Memo

From: Brad Glass, Chief Planning Official
Re: Building Permit #28231, 42 Besch Avenue
Date: August 16, 2021

Figure 1 - Approved Elevation

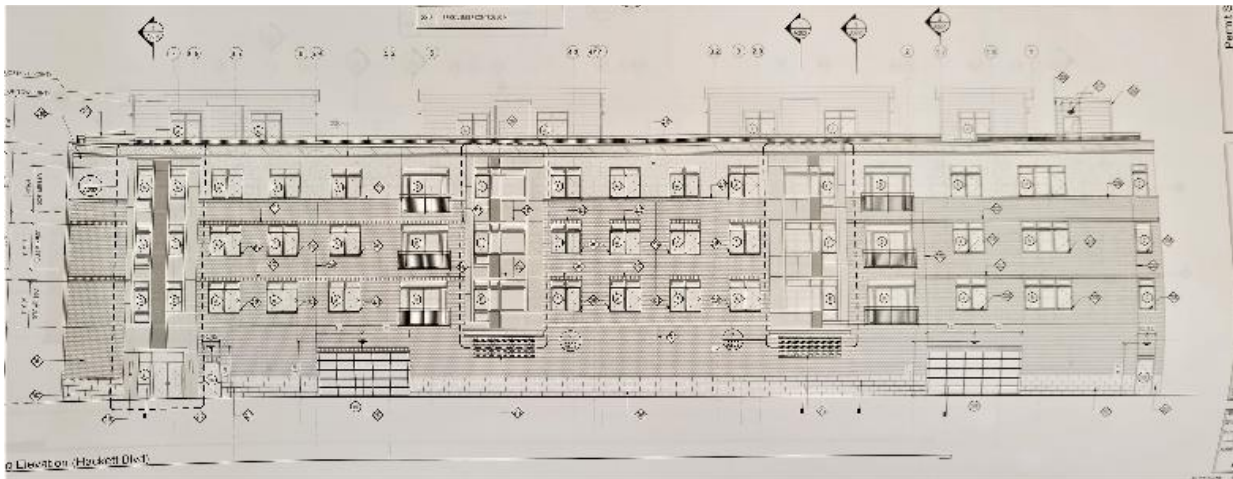
Additionally, our review identified a deviation from the approved development plan, namely in the form of a fifth story added to the building in accomodation of additional dwelling space. While the overall number of dwelling units within the building is proposed to remain the same, the proposed changes are inconsistent with the Planning Board endorsed plans and elevation drawings, and the additional story would cause the building to exceed the permissible height allowance within the applicable R-M zone district (four stories). If the applicant would like to proceed with the proposed change, an Area Variance and Site Plan Resubmission will be required. Application forms can be accessed on the City website or by contacting the Planning office at 434-6066 or dpd@albanyny.gov.
